CITY OF SNELLVILLE DEPARTMENT OF PLANNING & DEVELOPMENT PLANNING COMMISSION

CASE NUMBER:	#RZ 25-01
REQUEST:	Rezoning and Variances from UDO
LOCATION:	3,100 Block Rosebud Road, Snellville, Georgia
SIZE:	17.44± Acres
TAX PARCEL:	5100 023
CURRENT ZONING:	RS-30 (Single-family Residential) District
REQUESTED ZONING:	R-TH (Townhouse Residential) District
CURRENT FUTURE LAND USE MAP DESIGNATION:	Highway 78 East Activity Center/Node
DEVELOPMENT/PROJECT:	65-Unit Single-family (Attached) Townhome Development
APPLICANT/PROPERTY OWNER:	Sinocoin Investment, LLC Atlanta, Georgia 30326
CONTACT:	Jeff Timler Split Silk Properties, LLC Loganville, Georgia 30052 678-772-0202 SplitSilkProperties@gmail.com

CASE ANALYSIS

TO:	The Planning Commission
MEETING DATE:	January 28, 2025
FROM:	Jason Thompson, Director Department of Planning and Development
CASE NUMBER:	#RZ 25-01

Conceptual Zoning Plan - 17.44 Acres 3,100 Block Rosebud Road, Snellville

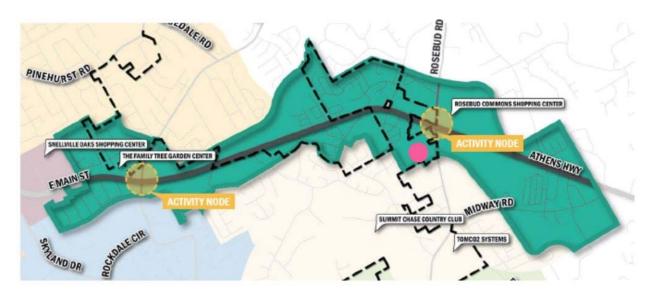
The conceptual rezoning site plan, dated 12-09-2024 (below) shows the general layout of the 65-unit townhome development with eleven (11) rear-entry townhome buildings and a single six-unit front-entry townhome building (Lots 14-19) with vehicular circulation provided by a 27-feet wide (back-of-curb) public/private road, 19-feet wide connectors and 16-feet wide one-way alleys.

A proposed 2,500 sq. ft. community clubhouse with greenspace, mailbox kiosk and thirteen (13) parking spaces is located at the beginning of the development at the shared full-access driveway on Rosebud Road. This driveway is shown to also serve as a secondary ingress/egress point for the adjacent mixed-use development to the north. Pedestrian circulation is provided by a 5-feet wide sidewalk with 2.5-feet planter adjacent to the internal public/private road.

Two (2) stormwater management ponds serving the development are located on the western portion of the site with over nine (9) acres of the total site (53%) undeveloped and provided as open space, mostly due to the unbuildable site area located within the Big Haynes Creek special stream buffer area.

The minimum required number of parking spaces is one (1) space per townhome unit plus one (1) space per (4) units which equates to 82 total spaces. The conceptual zoning plan shows 260 total spaces (assuming two (2) vehicle parking within each 2-car garage plus two (2) vehicle parking on the 17-feet wide by 22-feet long driveways) or 130 total spaces with no vehicle parking in the townhome garages. Unless prohibited by the Homeowner's Association, additional guest and visitor parallel parking could be provided in the street.

<u>Variance Analysis</u>: The rezoning site plan shows what appears to be a 2.5-feet wide planter strip between the 5-foot wide sidewalk and street roll-back curbing (see Variance #2). Therefore, no variance is required except to reduce the 5-feet wide planter requirement to 2.5-feet (see Variance #3).

<u>Variance Analysis</u>: Because of the 24-foot narrow townhome width and 17-foot driveway width on Lots 14-19, roll-back curbing is appropriate due to the limited space between each driveway apron; therefore, making the transition between the driveway apron and vertical curbing difficult and ineffective.

<u>Variance Analysis</u>: For streets categorized as *Local Street —Residential (Urban)*, the minimum required roadway pavement width is 27-feet excluding concrete curb and gutter which typically measures 1.5-feet wide, per side. Combined, with the 27-foot pavement width and 3-feet of curb and gutter on both sides of the roadway, the code requirement is 30-feet, measured back-of-curb. This 3-feet of additional street width allows for a safer environment for the passage of two vehicles at points where there is on-street parking.

<u>Variance Analysis</u>: In consideration with the denial recommendation for the reduced street width in Variance #3 above, the 2.5-foot planter width reduction is consistent with other townhome developments in the city and still allows the planting of understory street trees with a reduced canopy width in the planting area between the townhome buildings and sidewalk.

- A. **Approval** of RZ 25-01, application to amend the City of Snellville Official Zoning Map from RS-30 (Single-family Residential) District to R-TH (Townhome Residential) District.
- B. **Approval** of variance from Sec. 401-5.10.b. (Residential Curbing): To allow roll-back curbing in lieu of vertical curbing within the proposed townhome development on Lots 14-19. A 2.5-feet wide planter is required between the roll-back curbing and sidewalk.

- C. **Denial** of variance from Table 401-5.2. (Minimum Widths for New Streets and Project Access Improvements): To allow a minimum street width of 27-feet measured back-of-curb.
- D. **Approval** of variance from Table 401-4.2. (Streetscape Table): To reduce the 5-feet minimum planter width to 2.5-feet between the sidewalk and (internal) streets.

- 1. The property shall be developed in general accordance with the rezoning site plan entitled "Snellville Townhomes, Rosebud Road, Snellville, GA 30078", sealed, signed and dated 10-28-24 (stamped received Dec 13 2024), with modifications permitted to meet conditions of zoning or State, County, and City regulations. Substantial variation from the conceptual rezoning site plan, as determined by the Director of Planning and Development will require Mayor and Council approval, after submitting a Change in Conditions application and receiving recommendations by the Planning Department and Planning Commission.
